TECHNICAL REPORT RS-CR-80-1

**HUMAN ENGINEERING DESIGN CRITERIA  
FOR MODERN CONTROL/DISPLAY  
COMPONENTS AND STANDARD PARTS**

**FINAL REPORT**

20. ABSTRACT (Continue on reverse side if necessary and identify by block number) A study was conducted to identify requirements for modification of MIL-STD-1472B to include human engineering design criteria for modern controls and displays; and to reduce the incidence of requests for waiver of MIL-STD-1472 resulting from unavailability of standard parts. Recommended changes are presented with rationales and references.

**FIGURE 12A. ROCKER SWITCHES**

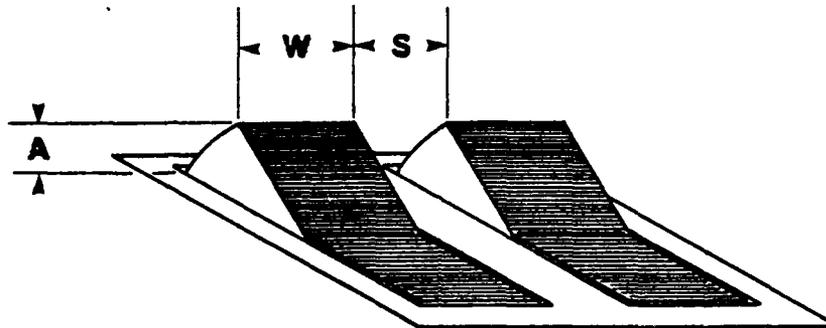
5.4.3.1.7.4 Dimensions, Resistance, Displacement, and Separation — Dimension, resistance, displacement and separation between adjacent edges of rocker switches shall conform to the criteria in Figure 12a.

**FIGURE 12B. SLIDE SWITCHES**

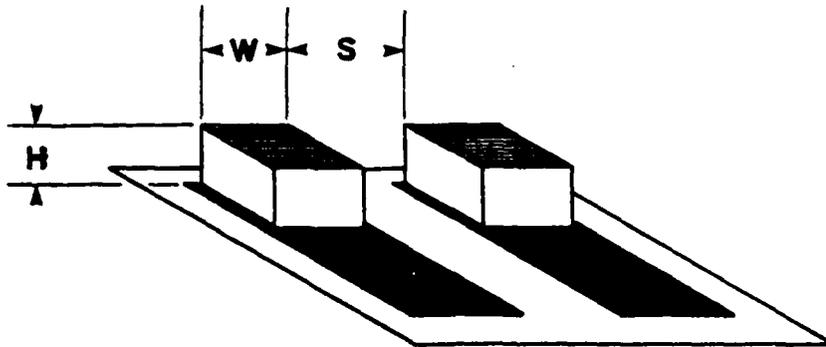
5.4.3.1.11 Slide Switch Controls — Recommended Change: (new paragraph)

5.4.3.1.11.3 Dimensions, Resistance, and Separation — Dimensions, resistance and separation of slide switch handles shall conform to criteria in Figure 12B.

FIGURE 13-A JOYSTICK CONTROL

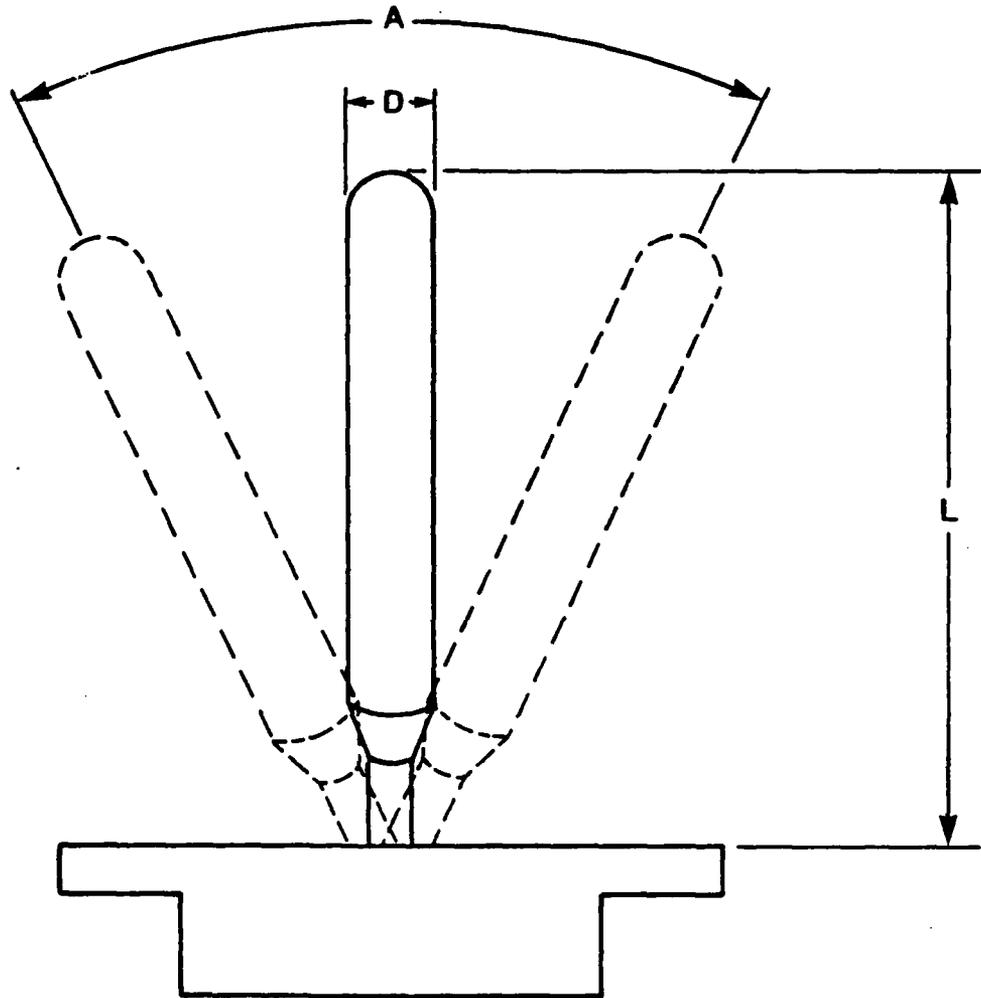
5.4.3.2 Continuous Adjustment Linear Controls — Recommended Change: (new paragraph)

5.4.3.2.3.3 Dimensions, Resistance, and Displacement — Dimensions, resistance and displacement (cone of rotation) for joystick controls shall conform to the criteria in Figure 13a.

**FIGURE 12A. ROCKER SWITCHES**

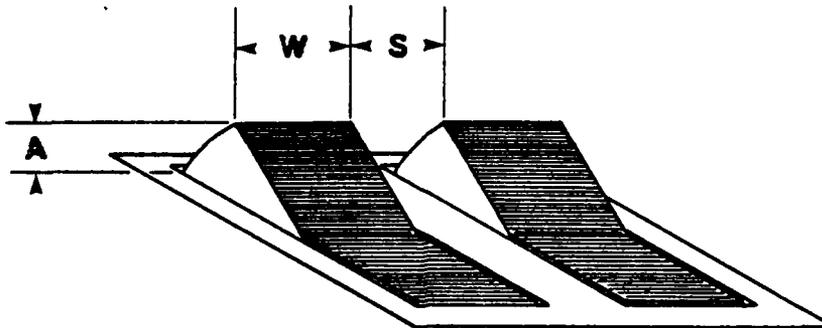
5.4.3.1.7.4 Dimensions, Resistance, Displacement, and Separation — Dimension, resistance, displacement and separation between adjacent edges of rocker switches shall conform to the criteria in Figure 12a.

**FIGURE 12B. SLIDE SWITCHES**

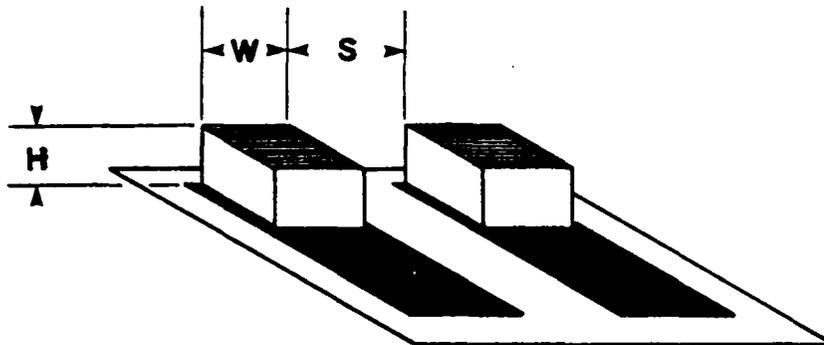
5.4.3.1.11 Slide Switch Controls — Recommended Change: (new paragraph)

5.4.3.1.11.3 Dimensions, Resistance, and Separation — Dimensions, resistance and separation of slide switch handles shall conform to criteria in Figure 12B.

FIGURE 13-A JOYSTICK CONTROL

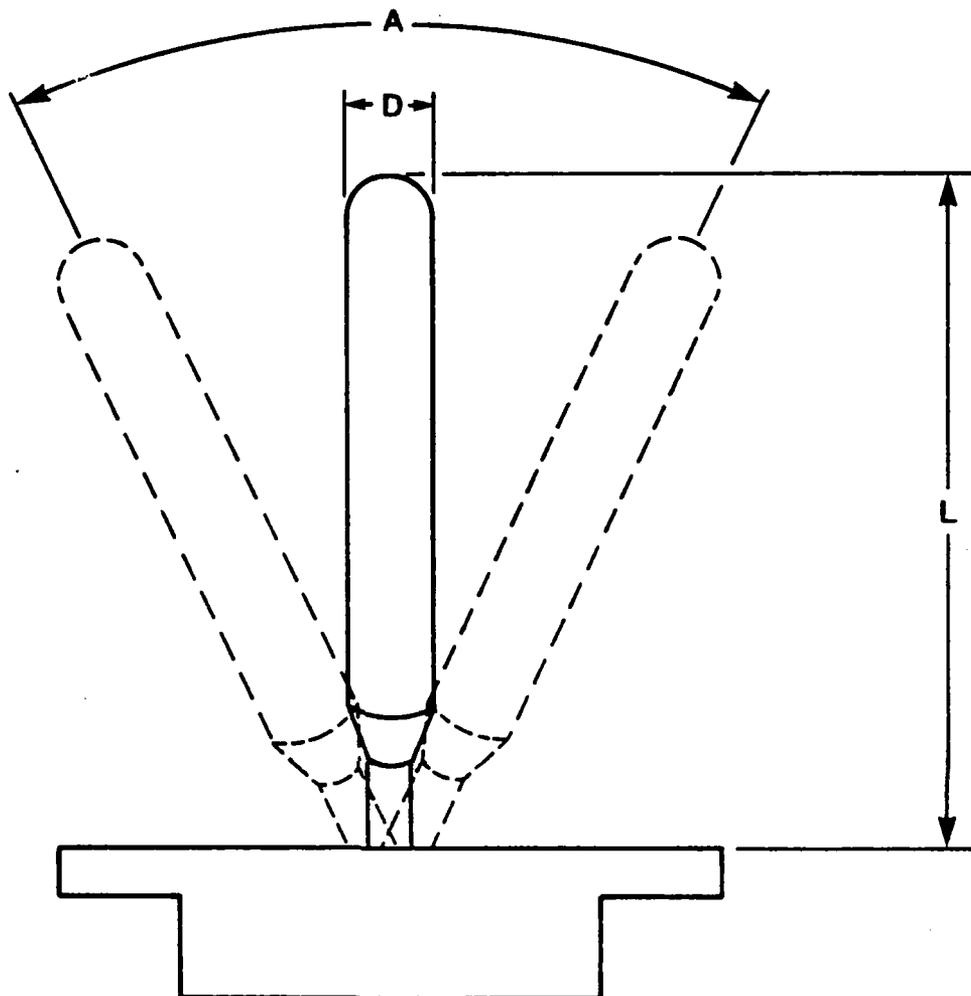
5.4.3.2 Continuous Adjustment Linear Controls — Recommended Change: (new paragraph)

5.4.3.2.3.3 Dimensions, Resistance, and Displacement — Dimensions, resistance and displacement (cone of rotation) for joystick controls shall conform to the criteria in Figure 13a.
